Project: 226052 DFCI-BIDMC New Cancer Hospital - 1 Joslin Place - Construction
1 Joslin Place
Boston, Massachusetts 02215

RFI #0-PB-130: 2-Hour Elevator Shaft Wall Continuity at Support Steel

15 TYPICAL DETAIL
ELEVATOR SHAFT AND TUBE STEEL SUPPORT
SCALE: 3" = 1'-0"

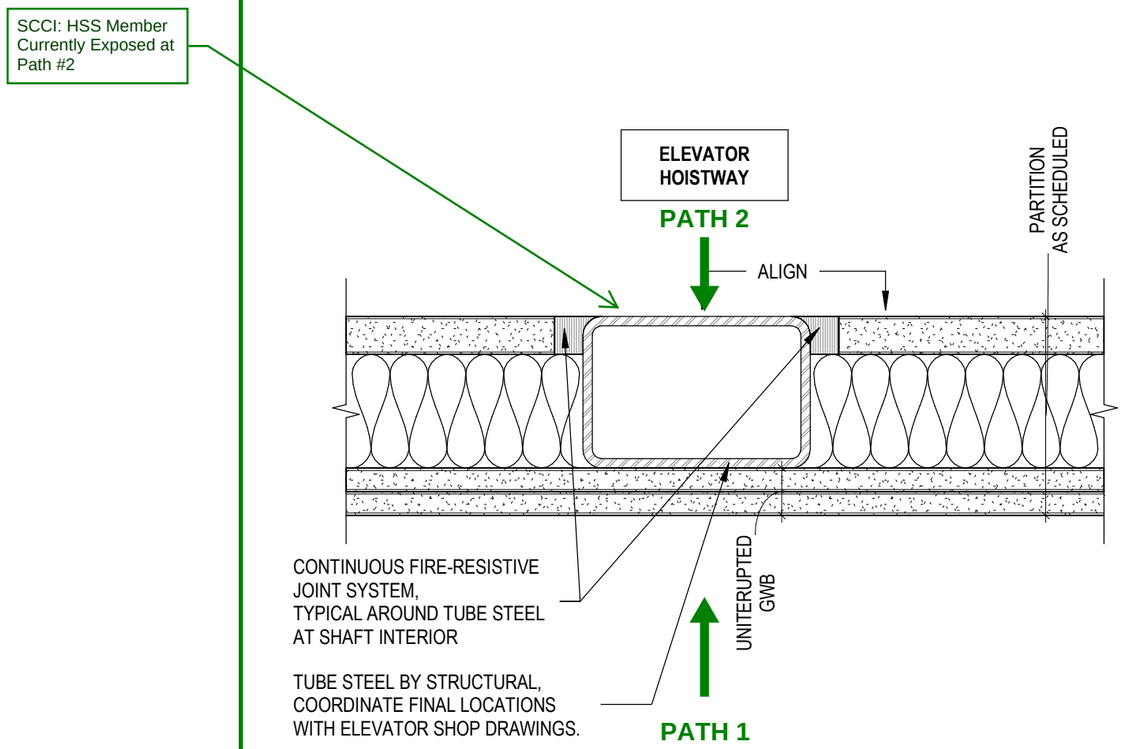
Please reference Detail 15/A7.40 and the attached markup showing the vertical HSS for elevator hoistway rail support. As detailed, the interior layer of GWB is interrupted by the exposed HSS.

The Massachusetts State Building Code, 10th Edition (2021 IBC) requires continuity of the 2-hour shaft enclosure (Section 713.5 & 707.5). It is understood that the vertical HSS can potentially be exposed to fire from either side of the hoistway (not simultaneously) and the assembly will require continuous protection from all sides exposed to heat.

- Whether this detail as drawn complies with an approved UL assembly or Engineering Judgement.
- If not, SCCI suggests encapsulation of the vertical HSS within the shaft wall assembly to maintain continuity of the interior GWB.
- If this does not meet the design intent, whether an intumescent coating or spray applied fire-resistive material should be applied to the exposed face of the HSS.

SCCI Question: Please confirm if this is a UL assembly or EJ. If not, please issue a revised detail clarifying the required fire-resistance protection at this condition

PAI 3/13/26 Response: Face of HSS tube steel in hoistway needs to remain exposed/ uninterrupted in order for the elevator brackets to be attached to it. Detail 15/A7.40 will be updated to match the below detail to maintain the required 2-hr fire rating separation. This will be captured in the next drawing issuance.

15 TYPICAL DETAIL
ELEVATOR SHAFT AND TUBE STEEL SUPPORT
SCALE: 3" = 1'-0"

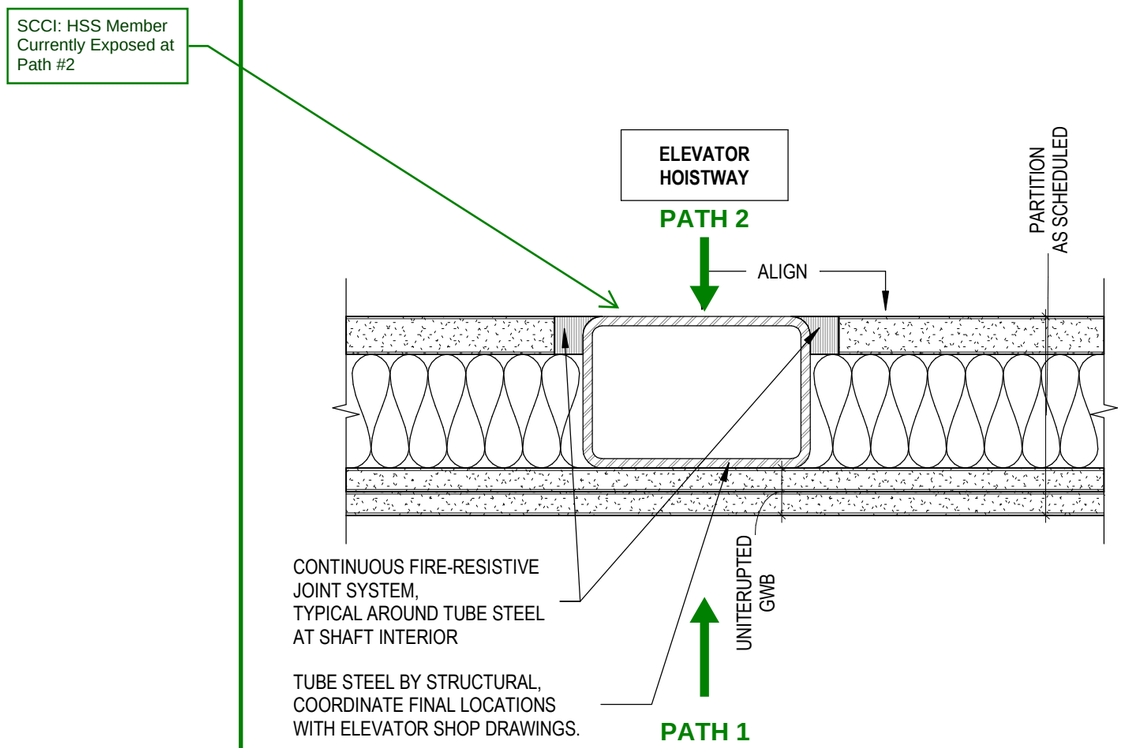
Please reference Detail 15/A7.40 and the attached markup showing the vertical HSS for elevator hoistway rail support. As detailed, the interior layer of GWB is interrupted by the exposed HSS.

The Massachusetts State Building Code, 10th Edition (2021 IBC) requires continuity of the 2-hour shaft enclosure (Section 713.5 & 707.5). It is understood that the vertical HSS can potentially be exposed to fire from either side of the hoistway (not simultaneously) and the assembly will require continuous protection from all sides exposed to heat.

- Whether this detail as drawn complies with an approved UL assembly or Engineering Judgement.
- If not, SCCI suggests encapsulation of the vertical HSS within the shaft wall assembly to maintain continuity of the interior GWB.
- If this does not meet the design intent, whether an intumescent coating or spray applied fire-resistive material should be applied to the exposed face of the HSS.

SCCI Question: Please confirm if this is a UL assembly or EJ. If not, please issue a revised detail clarifying the required fire-resistance protection at this condition

Face of HSS tube steel in hoistway needs to remain exposed/ uninterrupted in order for the elevator brackets to be attached to it. Detail 15/A7.40 will be updated to match the below detail to maintain the required 2-hr fire rating separation. This will be captured in the next drawing issuance.
